## Product Change Notice (PCN)

PCN Number: PCN-0451213R-01

Product(s) Affected: PJ-059BH

**NEV CUI DEVICES DETAIL / IMAGE**

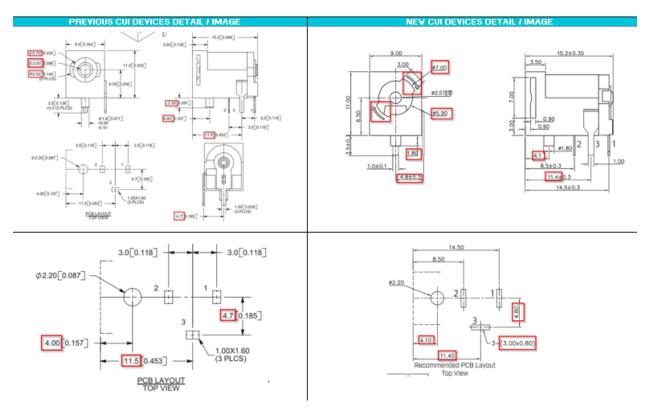
Description of Change: Minor Housing and footprint differences. Material Change on the housing and terminals. See image Below

MATERIAL	PLATING
center pin	copper	nickel
terminal 1	brass	silver
terminal 2	copper alloy	silver
terminal 3	brass	silver
plastic	PBT

DESCRIPTION	MATERIAL	PLATING/COLOR
center pin	brass	nickel
terminal 1	brass t=0.30	silver
terminal 2	bronze t=0.25	silver
terminal 3	brass t=0.30	silver
cover	PBT (UL94V-0)	black
housing	PBT (UL94V-0)	black
